PRODUCT MODIFICATION INSTRUCTIONS

QCF17

VCS3-RP2040-V2 UART power mod

SUNDANCE MULTIPROCESSOR TECHNOLOGY LTD.

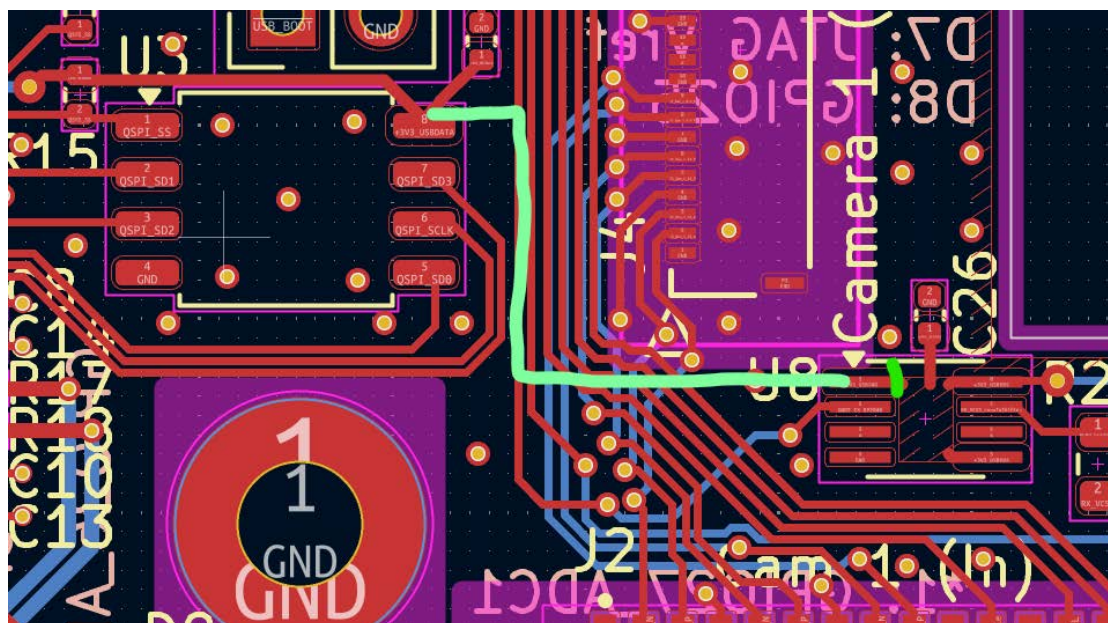
Cut this track (green) to isolate pin 1 of U8.

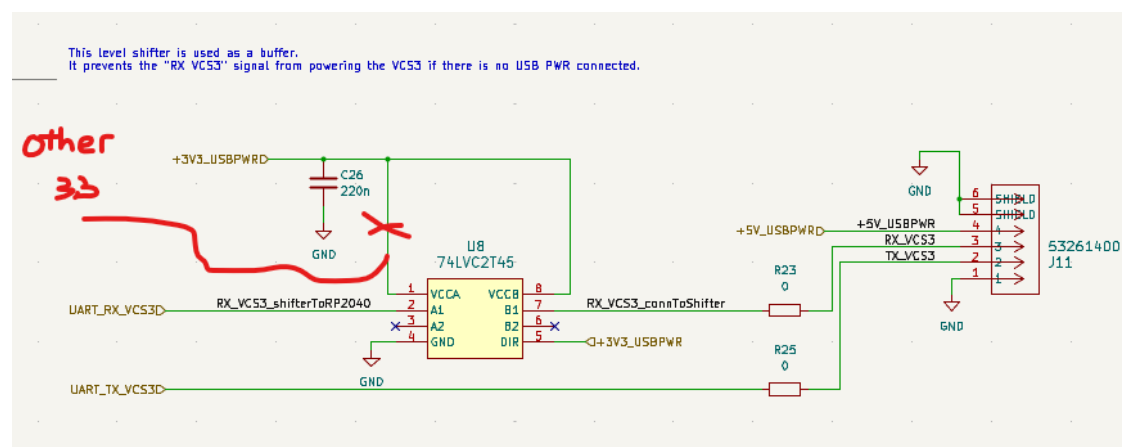
Add a wire from pin U8 pin 1 to pin 8 of U3 – the other green (the 8 pin flash chip):

We need to power the left-hand side of the buffer (the input in this configuration) from the same power supply as the RP2040 side of the TX pin. This means that when the RP2040 side of the board has no power, the left-hand side of the buffer also has no power so is pulled down. As shown below, pin 1 of the buffer needs to be isolated and connected to the +3V3_DATA rail.
